# WATER QUALITY MEMORANDUM

Utah Coal Regulatory Program

SUBJECT: Third Quarter 2015 Water Monitoring, Andalex Resources, Centennial Mine, C/007/0019, Task ID #4989

Figure 1. Surface to ground water levels, 1989-2015

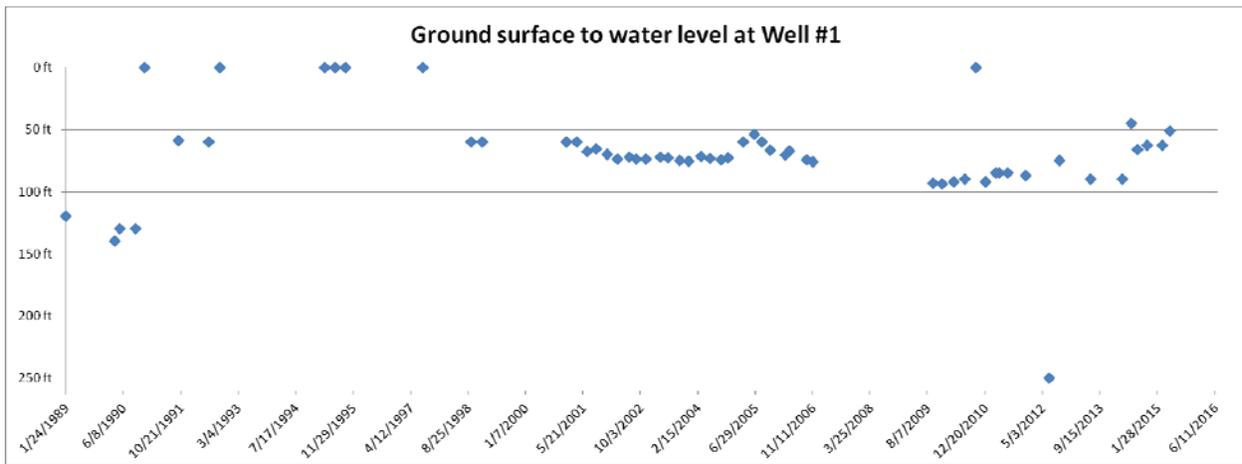
The Q3 2015 depth to water level measured 54 feet, which appears to be consistent with data from previous year's seasonal data.

The continued examination of the depth to water at Well #1 is required.
